Technical Information

OEnovia TD 200 / 250 / 200 H / 250 H
TWH 200 E / 250 E / 200 EH / 250 EH PRO
Heat pump water heater

New Fan
Spare parts compatibility

3. CU-HW-01 Software Version checking

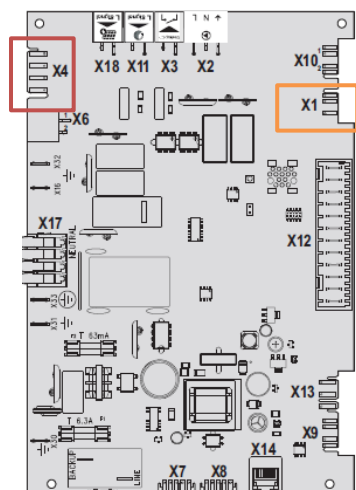
1) Press the ▤ button
2) Select icon **ⓘ** : **Version information**

3) The software version can be read:

→ Software version = **02.01**
